# Memorandum

**Re:** PC #18-013: European Crystal Hotel, 519 W. Algonquin Rd.

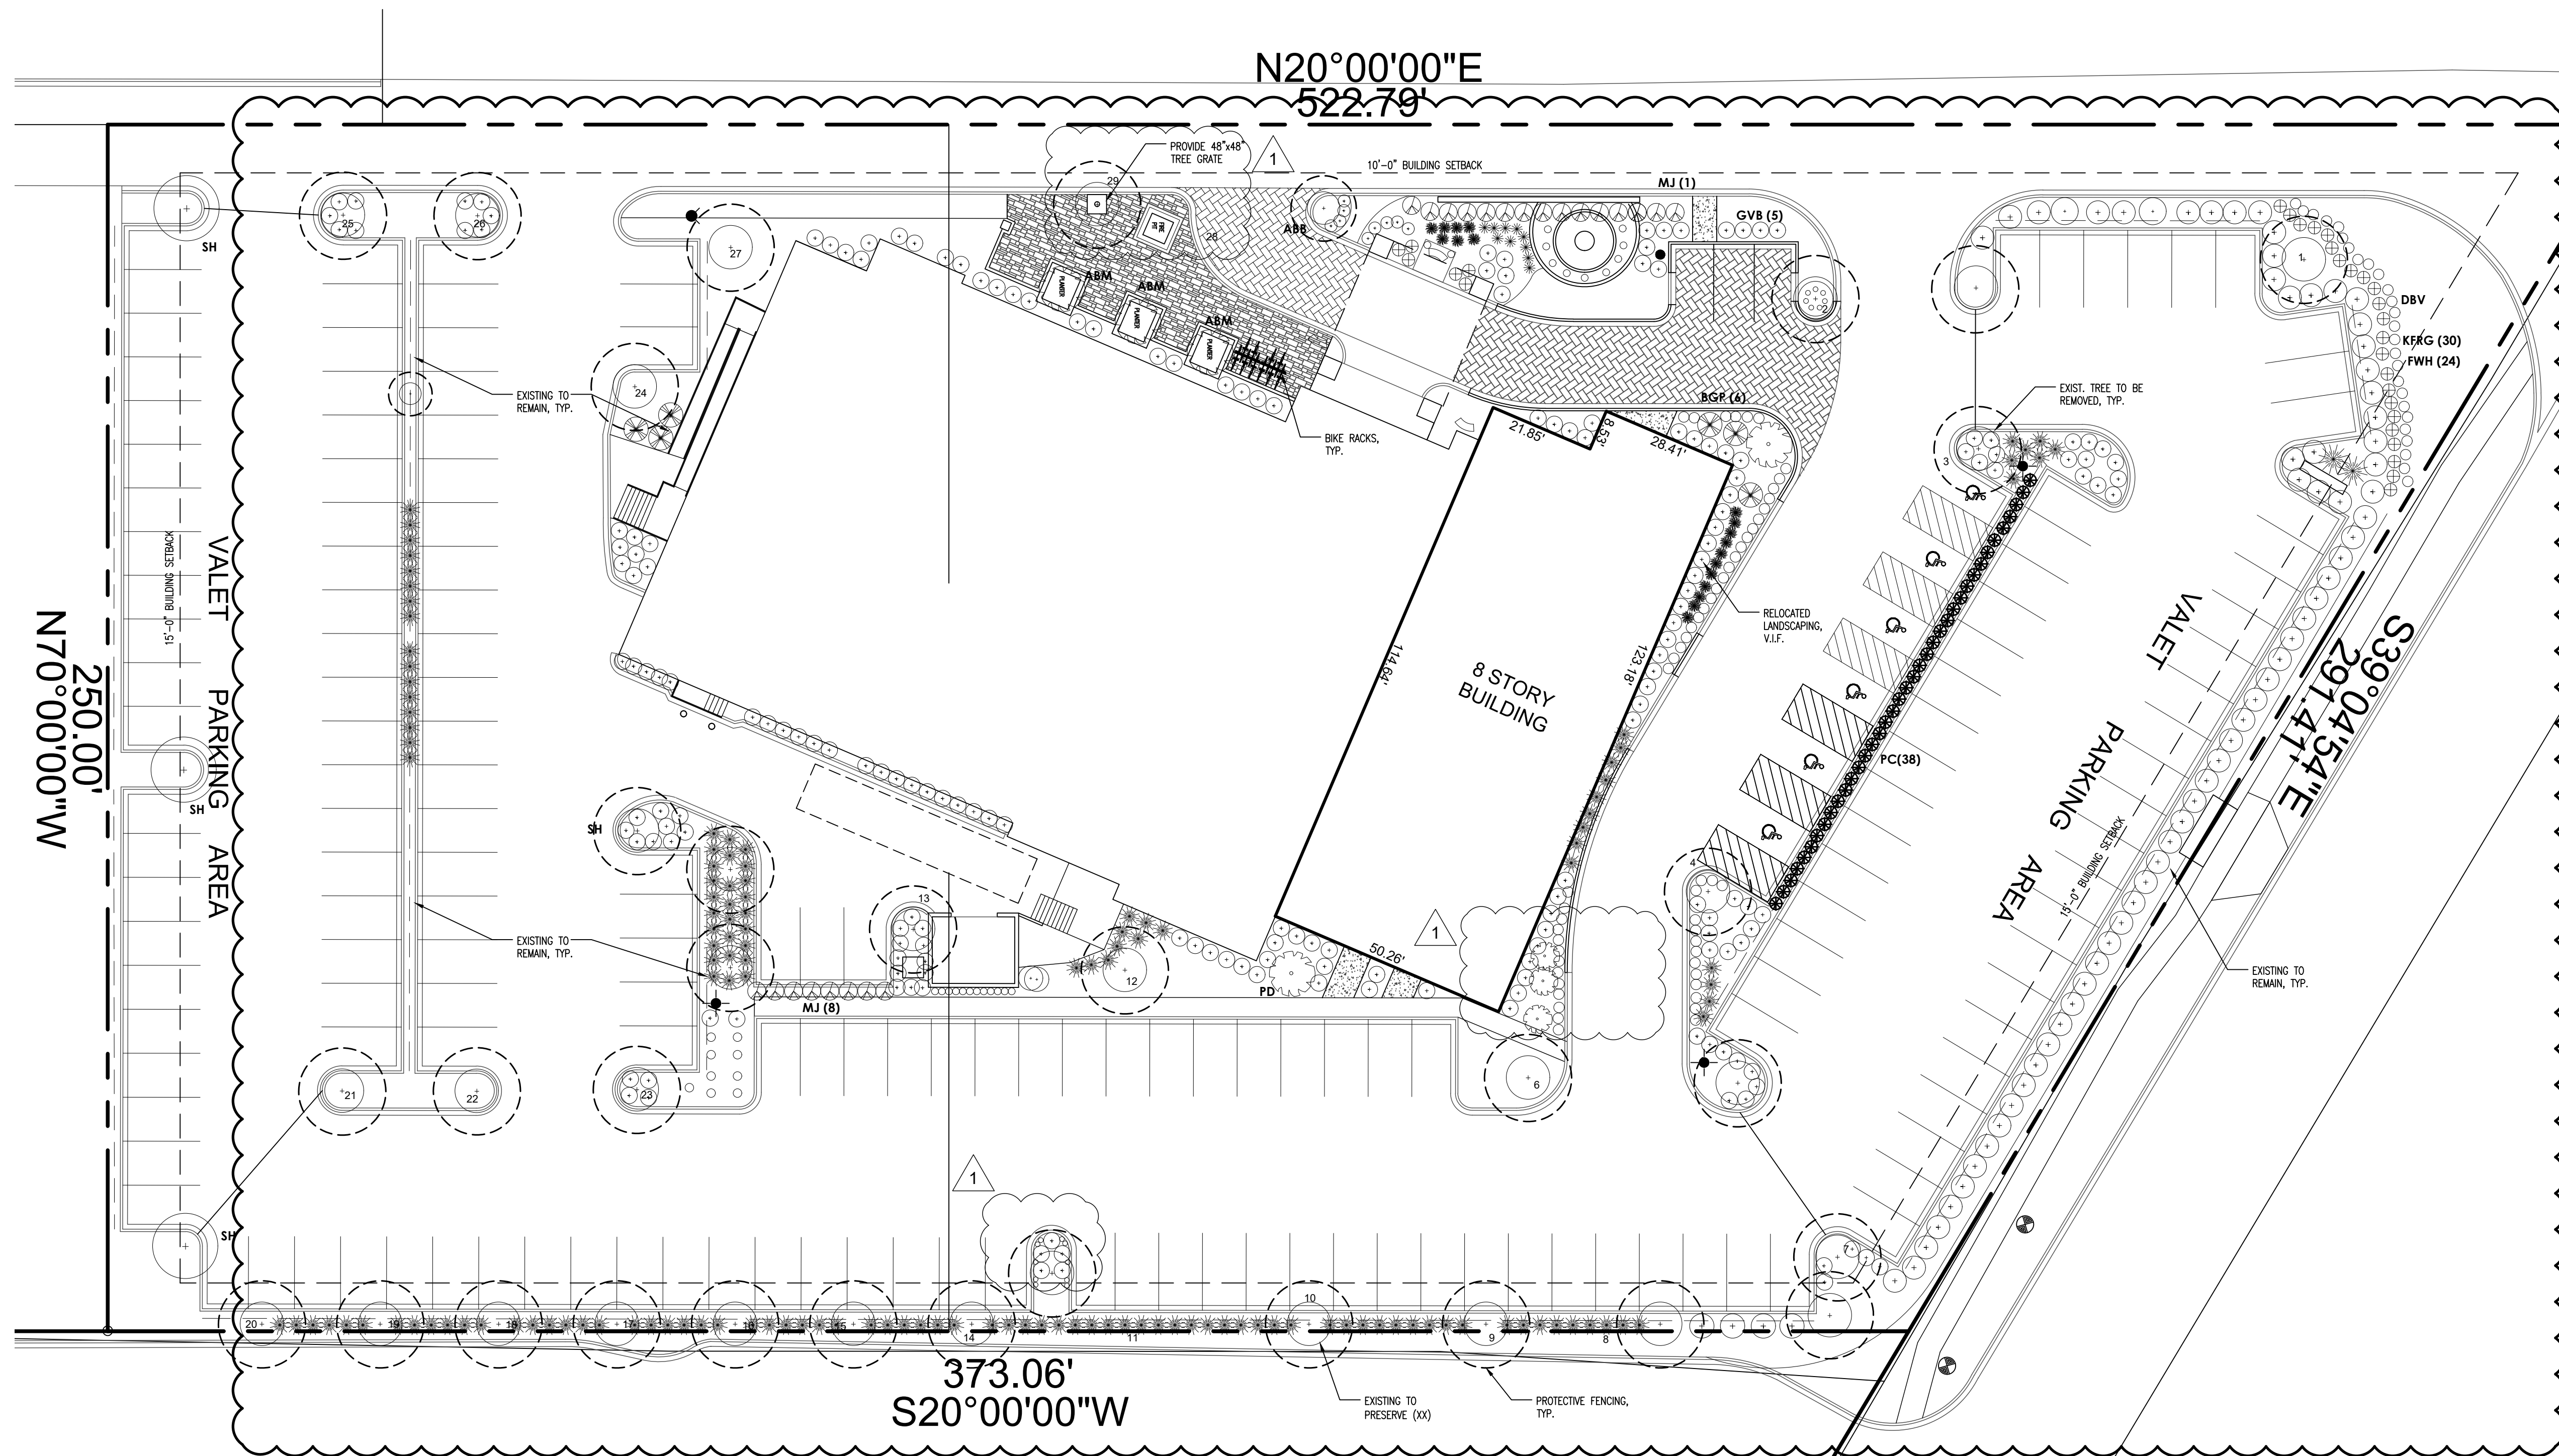
The current plans recommended by the Plan Commission show this proposed rooftop area to be constructed as one large room that would be used for storage. The petitioner is planning on incorporating utilities (plumbing, electric, etc.) within the storage area that would enable the future construction of the lounge to be “roughed-in” but not finalized and built out. The storage space would exist as a “vanilla box” until such time as approval is granted to allow full buildout of the lounge.

## 1 LANDSCAPE PLAN

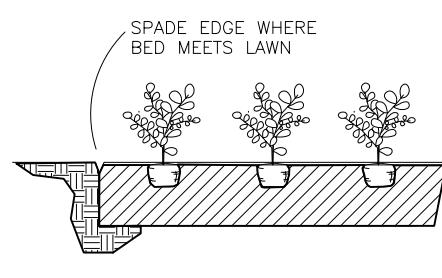
Both items have been provided by the petitioner and are attached to this memo. Relative to the landscape plan, staff has reviewed the plan and verified that the outstanding landscape issues have been addressed.

**1 PROPOSED SITE PLAN**  
SCALE: 1" = 20'-0"  
JULY 5, 2018

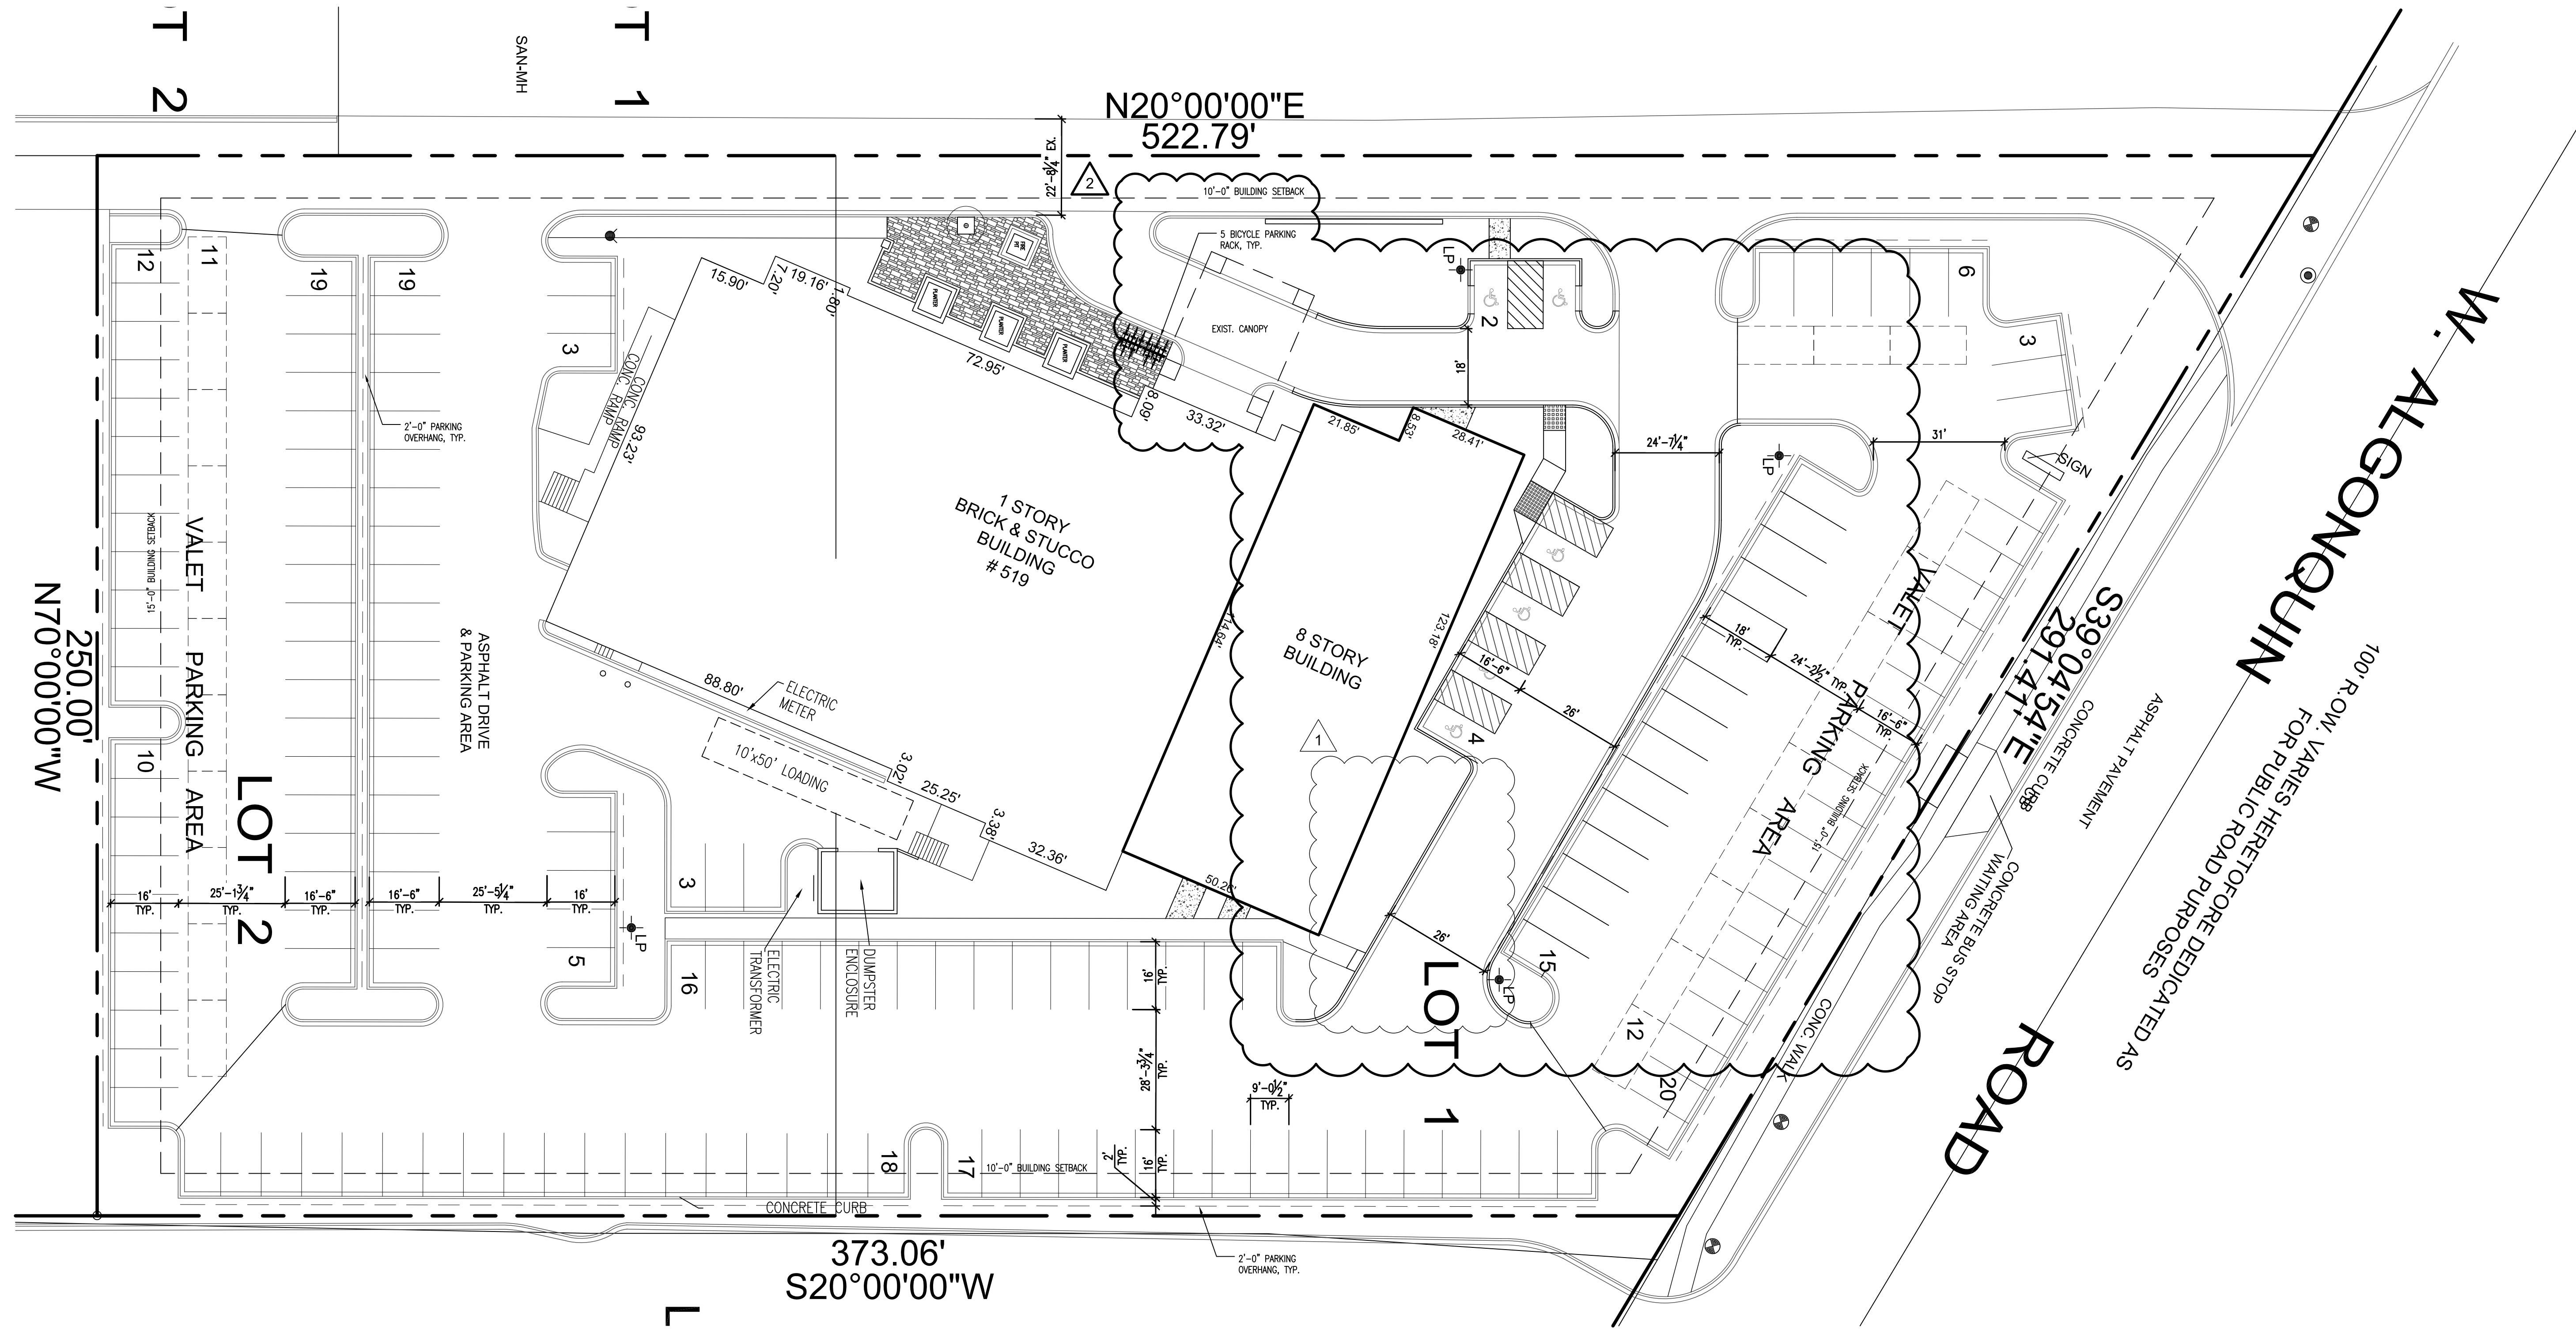
Relative to the fire lane, the petitioner has provided a revised plan showing a modified site layout to address the fire lane issues raised by the Building and Fire Department's. This plan has been reviewed by these departments and they have verified that their concerns regarding the fire lane on the north side of the building have been adequately addressed. However, the modified site layout causes the loss of four parking spaces, reducing the total on-site parking from 175 space to 171 spaces. Therefore, the following variation is needed:

- Variation to Chapter 28, Section 10.4, to reduce the required on-site parking (four space deficit) from 175 spaces to 171 spaces.

Staff believes that the proposed four-space parking deficit is acceptable given the off-site parking agreements that are in place for overflow parking, as well as the additional conditions of approval that are recommended by staff and the Plan Commission.
